South Texas Project
Units 1 and 2
Docket Nos. STN 50-498, STN 50-499
Response to NRC Bulletin 2001-01,
“Circumferential Cracking of Reactor Pressure Vessel Head Penetration Nozzles”

**Response to NRC Bulletin 2001-01
Circumferential Cracking of Reactor Pressure Vessel Head Penetration Nozzles**

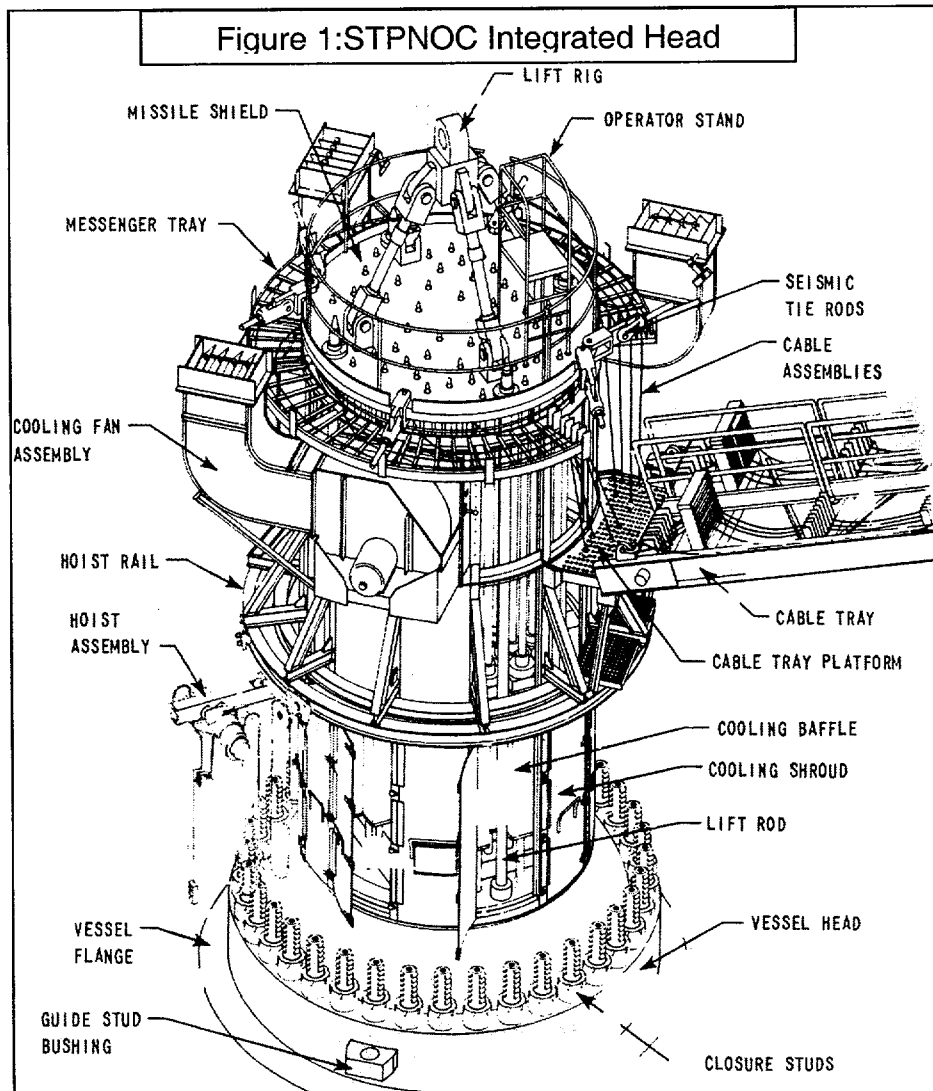
- e. a description of the configuration of the missile shield, the CRDM housings and their support/restraint system, and all components, structures, and cabling from the top of the RPV head up to the missile shield. Include the elevations of these items relative to the bottom of the missile shield.**

Table 1 provides relative elevations of various significant components to the missile shield. The STP integrated head package consists of the head lift rig, missile shield, seismic supports, control rod drive mechanisms (CRDM), CRDM cooling system, and the power and instrumentation cabling. Figure 1 shows the assembled system attached to the reactor vessel head.

Reactor Missile Shield	The missile shield is a circular, steel plate attached to three lift rods that extend down to the reactor vessel head. The shield is laterally supported by six seismic tie rods attached to the reactor cavity wall. The missile shield may be detached to provide access to the CRDMs. In addition to providing containment for missiles that may be ejected from the head, it also provides seismic support for the CRDMs and serves as a spreader for the head lift rig.
CRDM Cooling Shroud	The CRDM Cooling Shroud is a generally cylindrical steel structure that maintains a suitable atmosphere for the CRDMs in order to protect and prolong the life of the CRDM coils. The CRDM cooling shroud encircles the RPV head insulation and impedes access to the insulation panels.
RPV Head Penetrations	There are 79 RPV head penetrations. Seventy-six (76) of these penetrations are J-groove welded RPV head penetrations, of which 74 are the CRDM type penetrations. Of these 74 penetrations, 57 penetrations are used for the CRDMs, four (4) penetrations are spares mounted with capped latch assembly housings, seven (7) penetrations are spares capped with female flanges, two (2) penetrations contain instrumentation for the Reactor Vessel Water Level System (RVWL), and four (4) penetrations contain thermocouple connections. The two (2) remaining J-groove welded RPV head penetrations are for the head vent and the degasification line. The three (3) remaining penetrations are OD butt welded penetrations containing the internals support housing lift rods.

CRDMs	The CRDMs are located on the dome of the reactor vessel. The CRDM consists of four separate subassemblies. They are the pressure vessel (housing), coil stack assembly, latch assembly, and the drive rod assembly. The CRDM pressure vessel is connected by a seal-welded threaded connection to the CRDM RPV head penetration and restrained at the top by the missile shield. The other CRDM subassemblies are external to the CRDM pressure vessel and provide for withdrawal or insertion of the rod control cluster assemblies (RCCAs), and for RCCA position indication. All power and instrumentation cable assemblies traverse up from the head penetration components to the messenger tray out to the cable tray.
RPV Head Insulation	See response to 1.c.
CRDM RPV Head Penetrations	The CRDM RPV head penetrations provide a pressure boundary from the RPV to the threaded seal-welded connection for the CRDMs. The penetrations are structured to provide a uniform height transition from the round reactor vessel dome to the CRDM housing.
